1997 - 1998 Corvette: Service Bulletin: Hiss Type Noise Coming From Weatherstrip When Closing Right or Left Door

Subject: HISS TYPE NOISE COMING FROM WEATHERSTRIP WHEN CLOSING RIGHT AND/OR LEFT DOOR (ADD RELIEF HOLE)
Source: Chevrolet Dealer Technical Service Bulletin
Number: 83-15-07

Models: 1997-1998 Chevrolet Corvette Coupe and 1998 Chevrolet Corvette Convertible

Figure 1

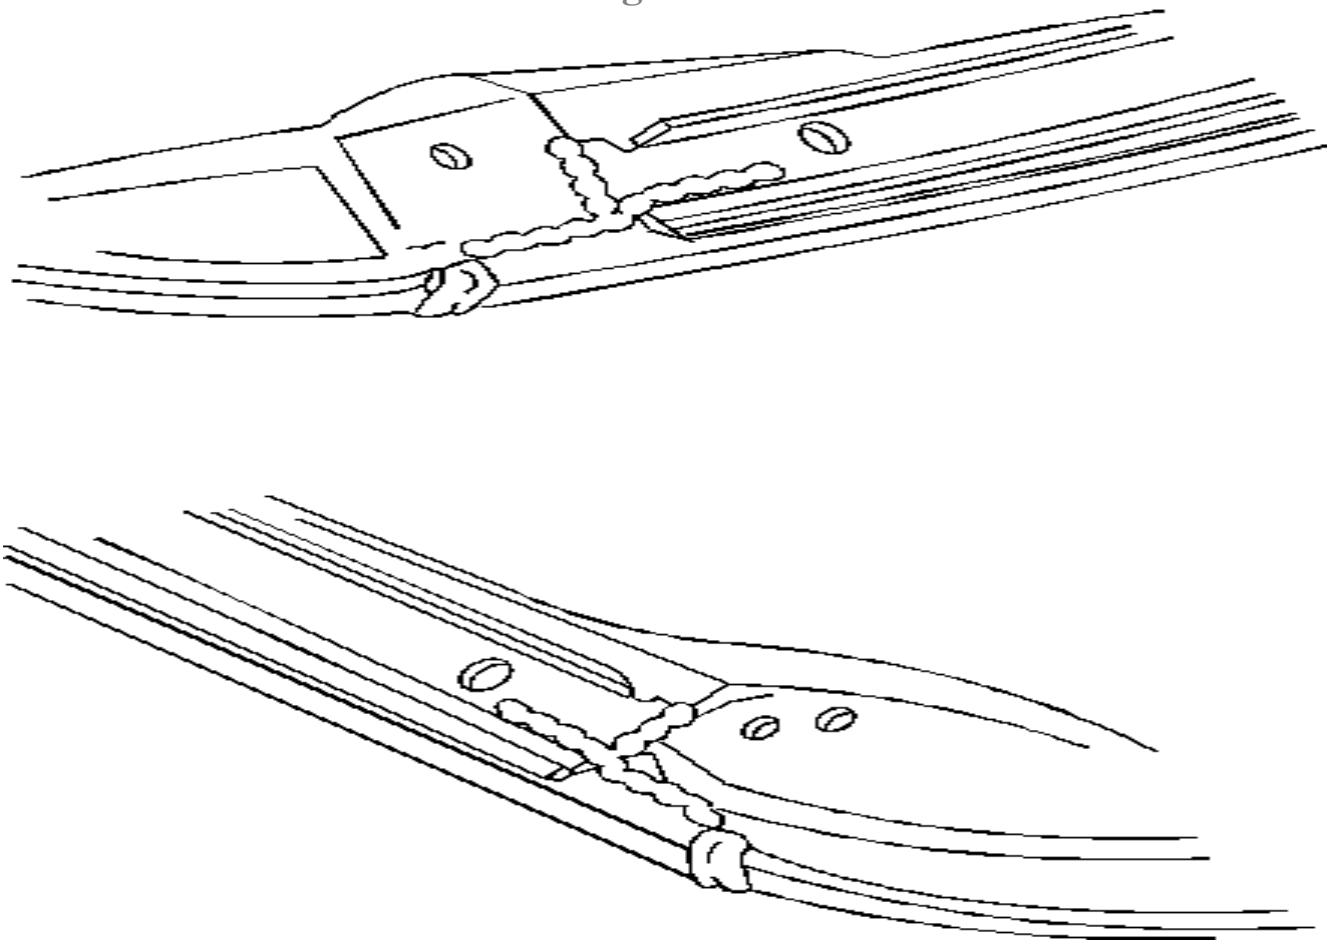
Condition: SOME CUSTOMERS MAY COMMENT ON A HISS TYPE NOISE COMING FROM THE WEATHERSTRIP WHEN CLOSING THE RIGHT AND/OR LEFT DOOR WITH THE GLASS IN THE FULL UP POSITION.

1. REMOVE THE WEATHERSTRIP ABOVE THE DOOR GLASS AND CUT AN AIR RELIEF HOLE 3MM WIDE (.12 IN) BY 10MM LONG (.4 IN) IN THE BACK OF THE WEATHERSTRIP.

2. RESEAL THE FRONT AND REAR CORNERS ON THE COUPE OR THE FRONT CORNER OF THE CONVERTIBLE WITH WEATHERSTRIP ADHESIVE; 3M(R) P/N 08011, OR EQUIVALENT. SEE FIGURE 1.

3. REINSTALL WEATHERSTRIP.
